RATIONALE

BOLT, MACHINE - DOUBLE HEXAGON EXTENDED WASHER HEAD, DRILLED, PD SHANK, SILVER PLATED, CORROSION AND HEAT RESISTANT STEEL, UNS S66286, 130 KSI MIN, .1900-32 UNJF-3A

AS9574™
SHEET 1 OF 2

REV. B

FIGURE 1 - BOLT

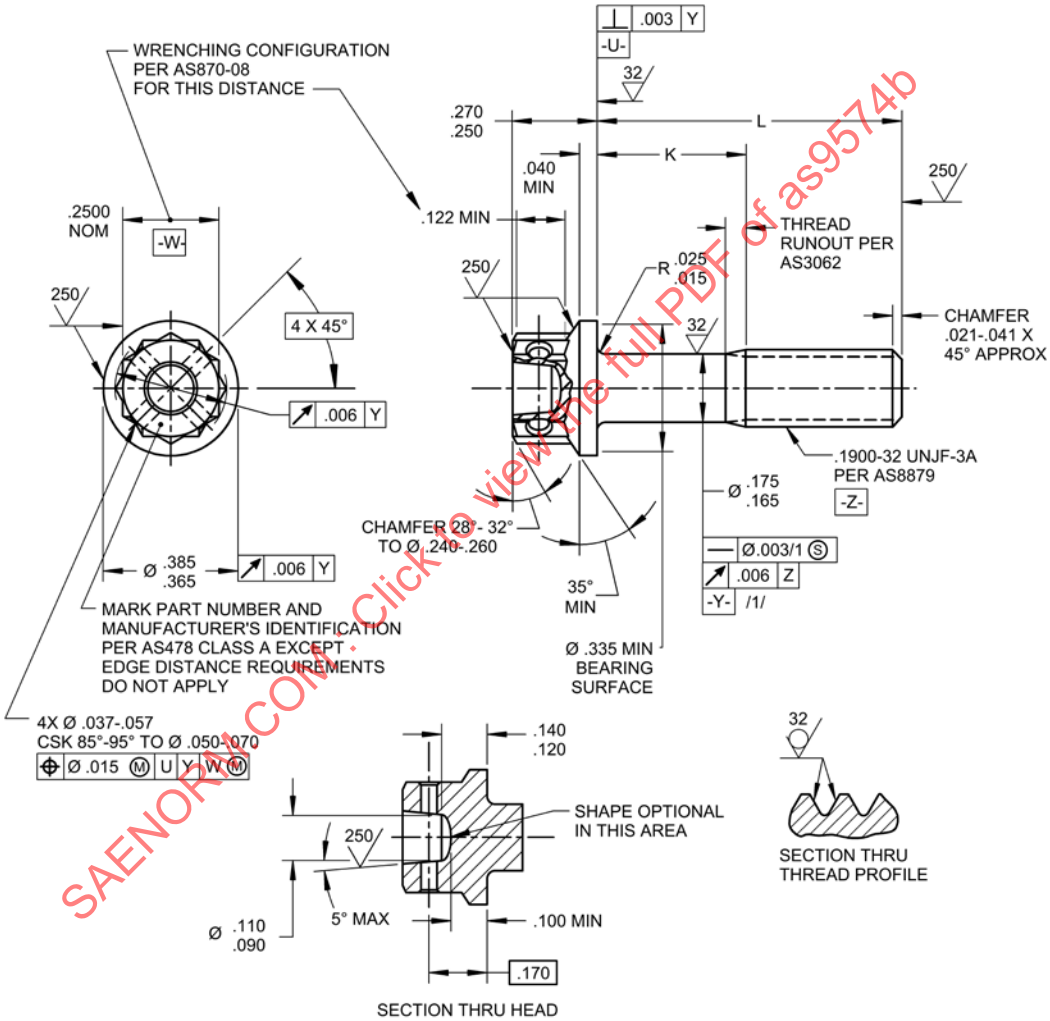
UPDATE THREAD SPECIFICATION TO AS8879, ADD OPTIONAL SHAPE FOR BOTTOM OF LIGHTENING HOLE, ADD TERTIARY DATUM FOR POSITION OF SAFETY WIRE HOLE, RELOCATE RUNOUT REQUIREMENT ON BOLT HEAD TO ACROSS POINTS, DELETE RADIUS REQUIREMENT AT TRANSITION FROM WRENCH PAD TO BASE FLANGE, ADD MINIMUM SENSITIVITY LEVEL TO DRAWING NOTE 5, ADD DATUM NOTE 1 FOR SHORT BOLT LENGTHS, RELOCATE DATUM W AND GENERAL EDITORIAL UPDATE.
